CITY OF HOLLYWOOD, FLORIDA
 UTILITY CONSTRUCTION PROJECT
CONTRACT CHANGE ORDER No. 2

CITY FILE No: 19-9119A

PROJECT: DEEP INJECTION WELLS NO.

3 AND NO. 4 PUMP STATION

DWG.NO. **77163-2 .4** SCALE NONE REV. **B**

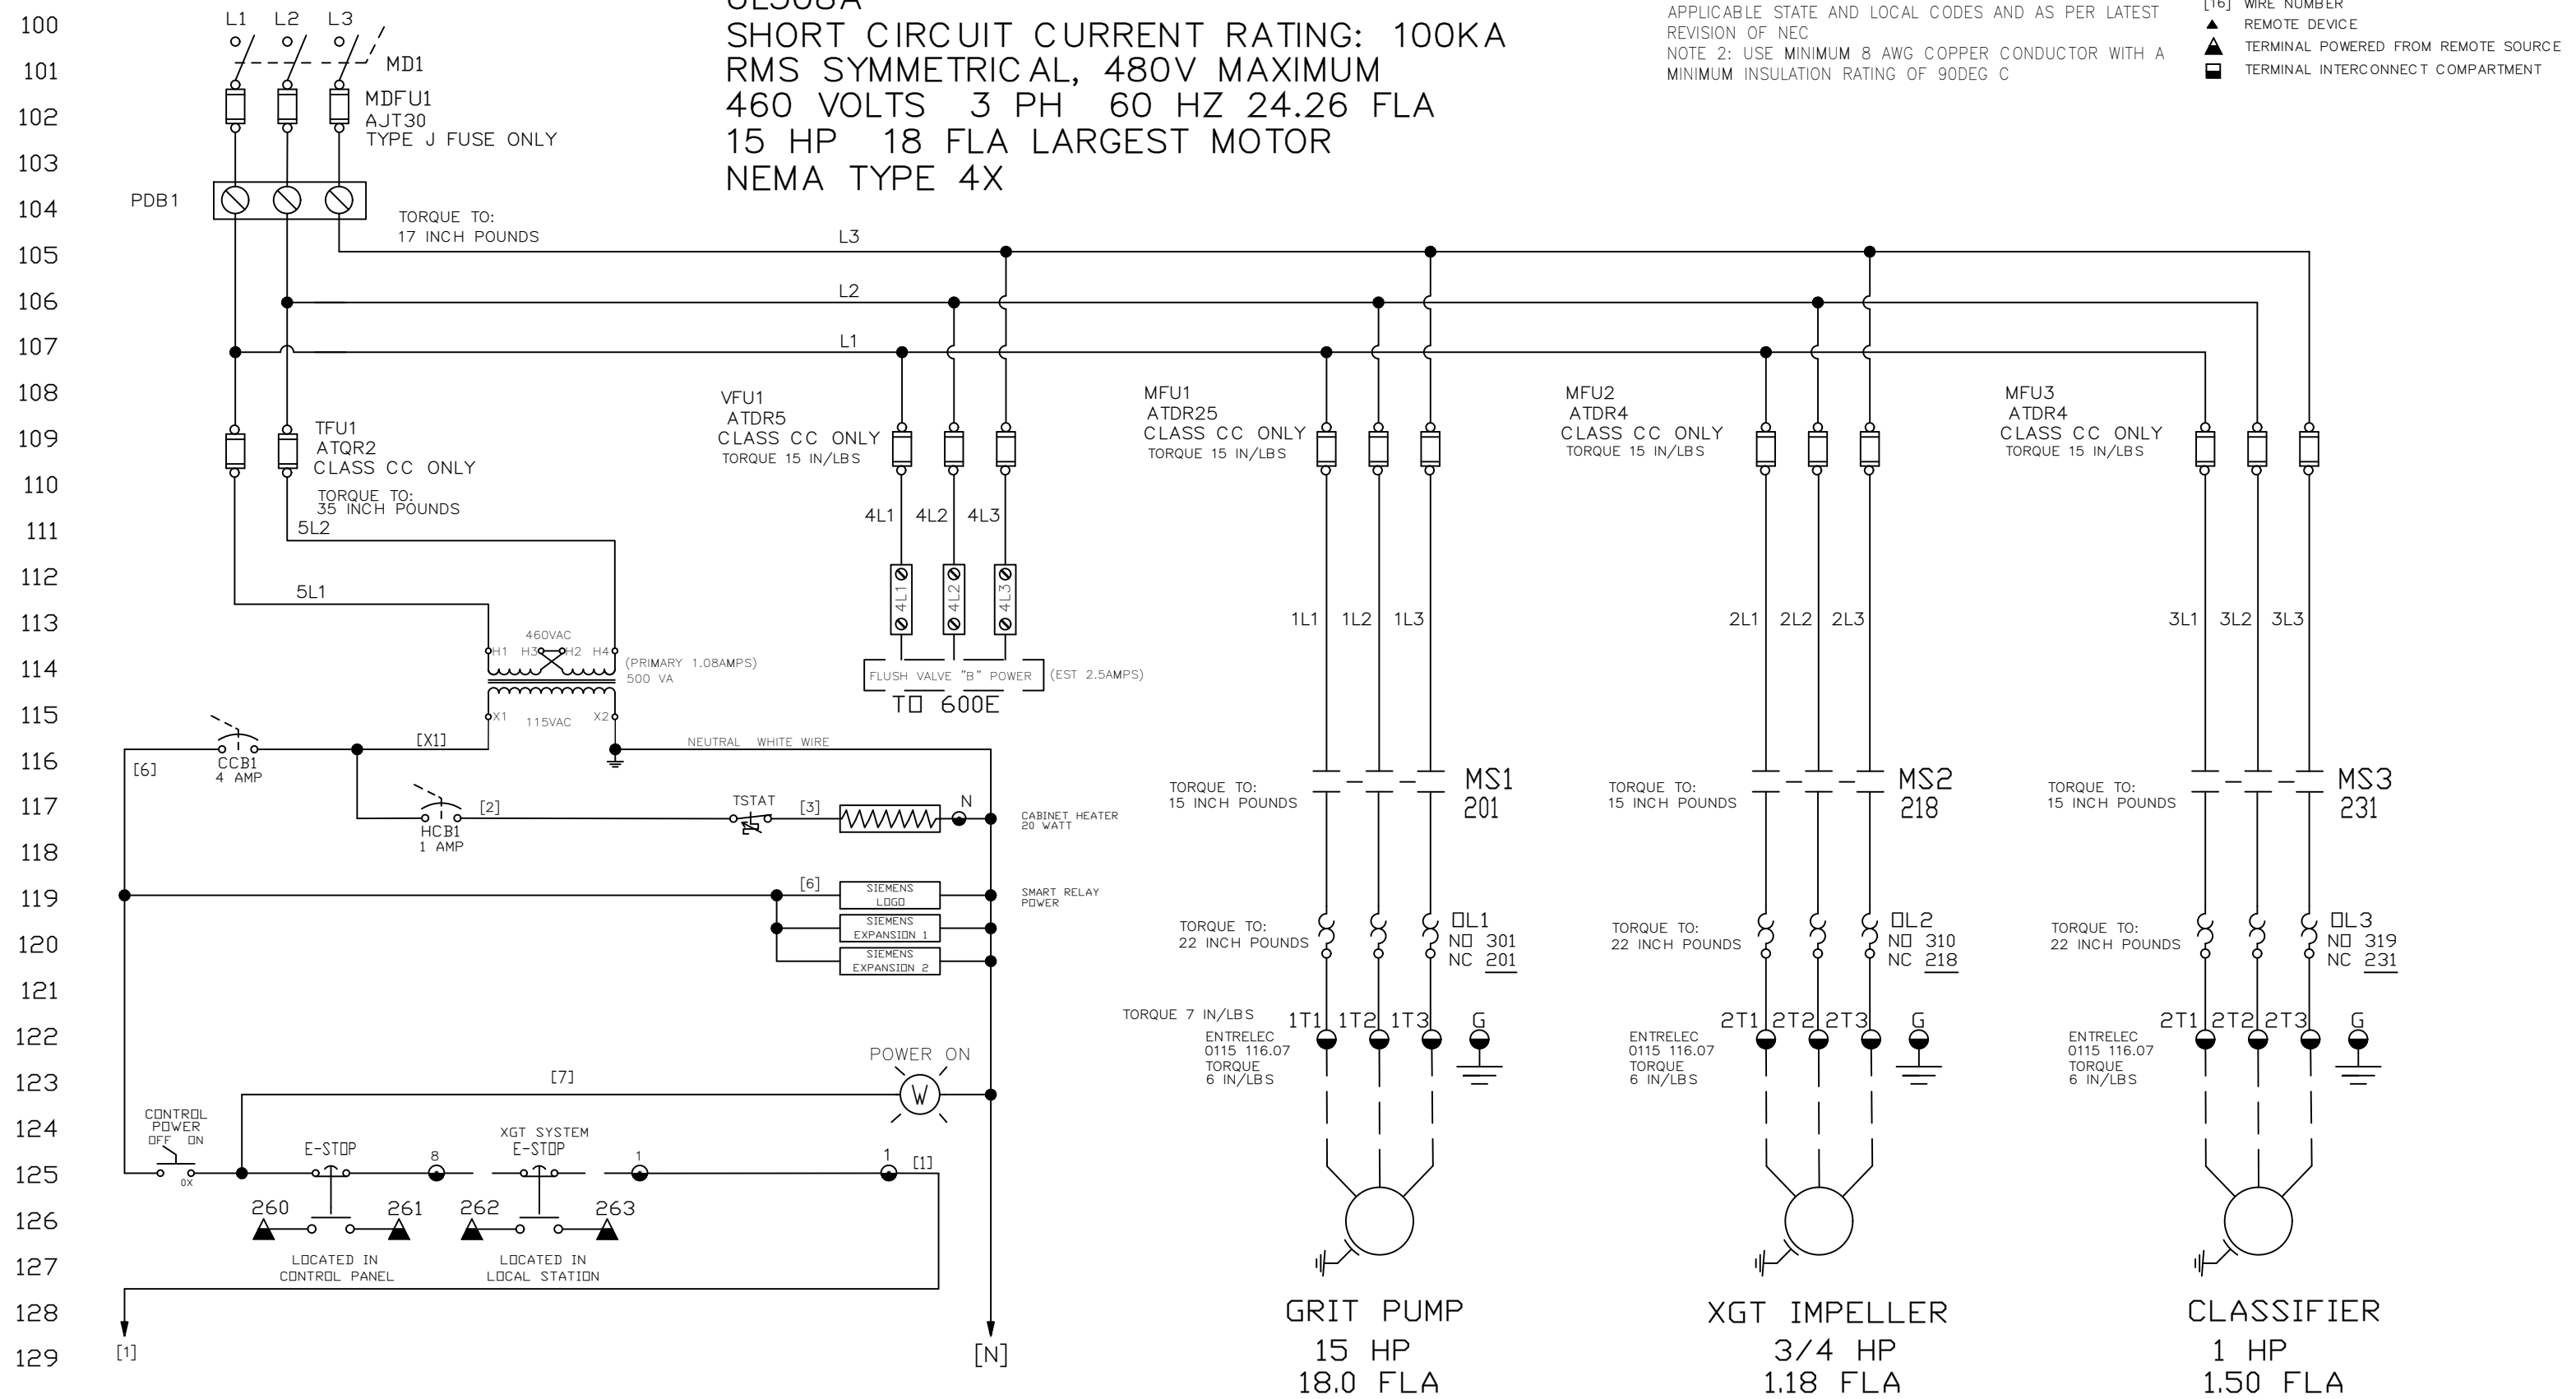
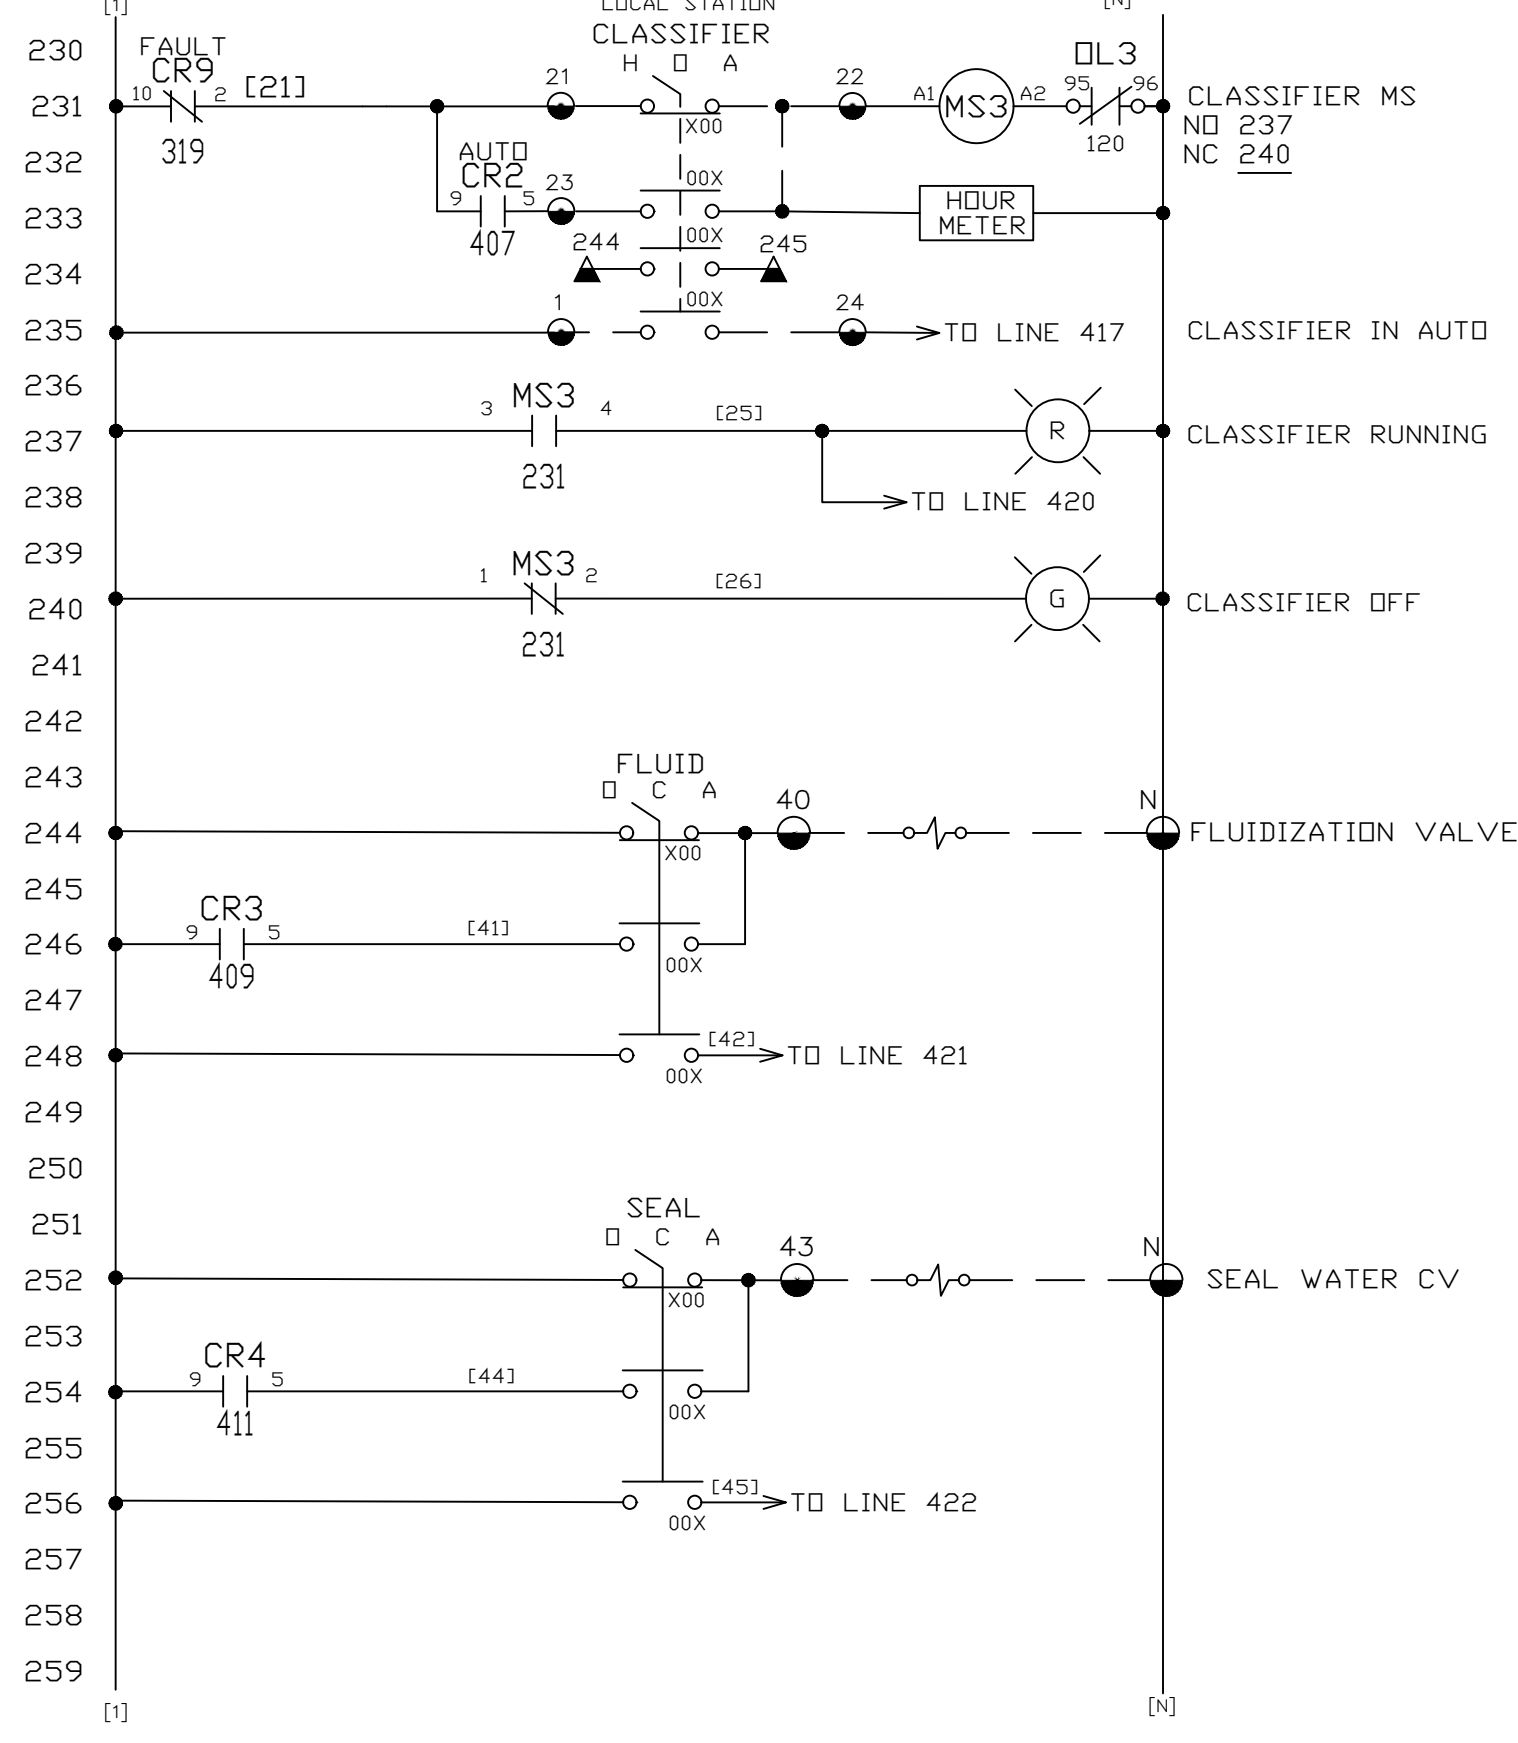
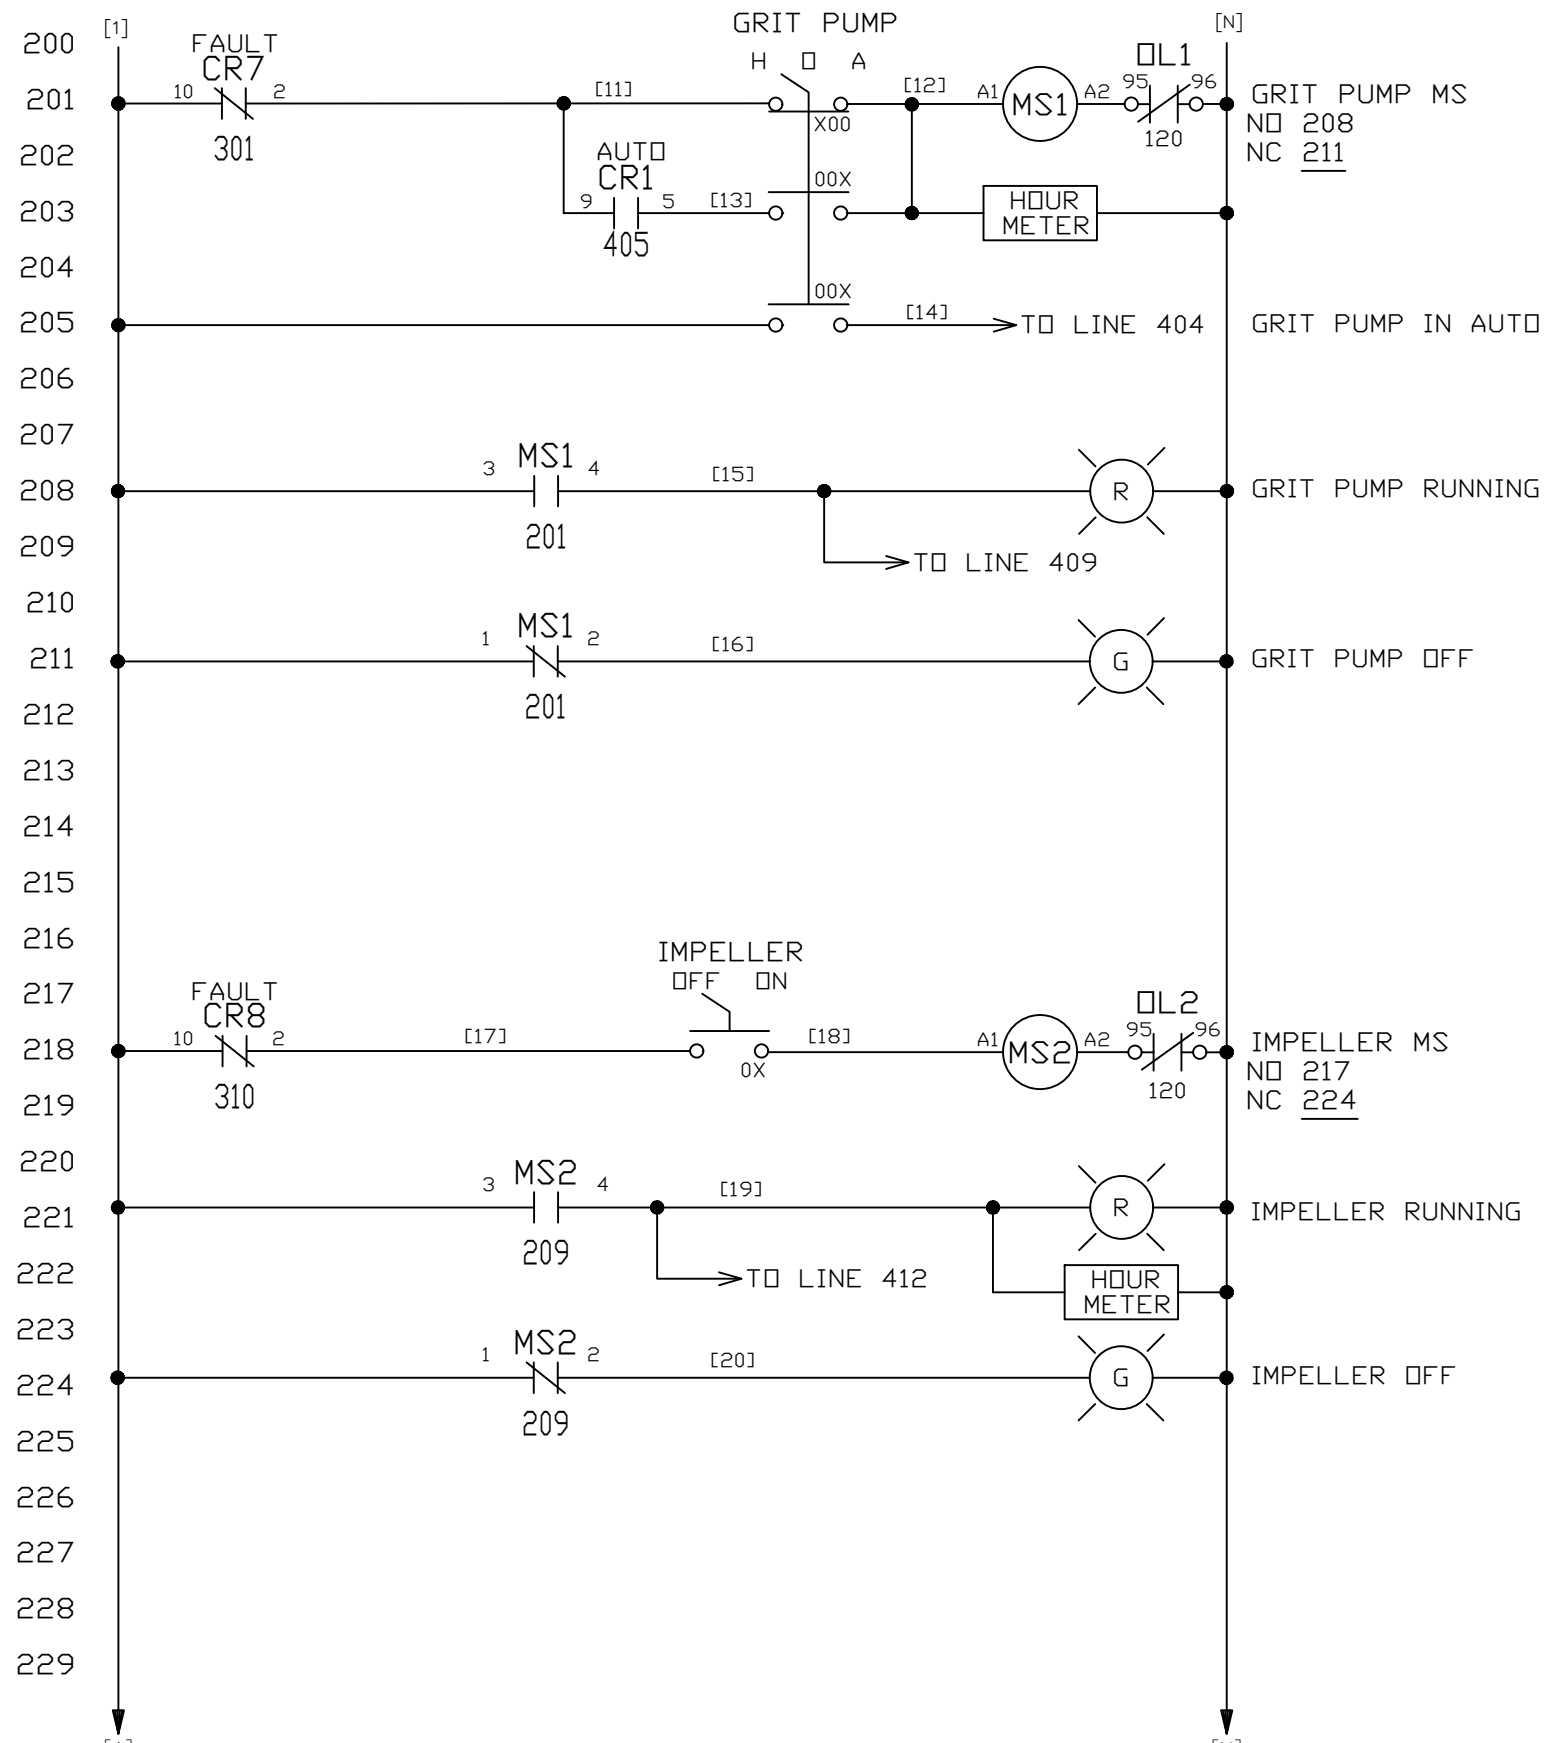
The original design called for a 5.0 HP, 460V, 3-phase motor for sample pump (PMP-1021), which is the lower zone submersible pump at the monitoring well. The power system requirements and control panel were designed to accommodate a pump utilizing those characteristics. Due to manufacturing and scheduling issues, the supplier cannot provide a pump with as specified causing the need to modify the component requirements of control panel LCP-1021 to accommodate a ½ HP, 230V, 1-phase powered pump.

It was also determined that LCP-1021 could be utilized as specified to become a Vendor Control Panel (VCP-3070-4) for the portable submersible pump (PMP-3070-4) at the IWPS, which had no control panel called for, but needed one.

Note: Is this proposed price entirely for a new LCP-1021 in accordance with the latest submittal # 40 67 00-02-01.3 Pump Control Panel for the new LCP-1021 (1/2HP, 230V, 1-ph)? This control panel submittal still has an RAR review status.

Or does the proposed price include cost to modify the old LCP-1021 (5HP, 460V, 3-ph) to work on the 10HP, 3-ph pump PMP-3070-4 (portable pump) which the required control modifications have not been submitted by the Contractor or reviewed by the Engineer?

Complete supply, installation, and commissioning of the new pump control panel LCP-1021 for the 1/2HP, 230V, 1-phase monitoring well pump, which shall be in accordance with the approved submittal drawings. (Note: The installation and commissioning cost are already included in the original LCP-1021 with 5HP, 460V, 3-ph pump)

Complete supply and testing of existing pump control panel LCP-1021 which is being converted or modified accordingly, and re-labeled as new pump control panel VCP-3070-4 suitable for use on the 10HP, 460V, 3-phase portable sump pump.

The modified or retrofitted LCP-1021 that becomes the new VCP-3070-4 has not been submitted or reviewed so the EOR cannot make a conditional approval or acceptance on this panel.
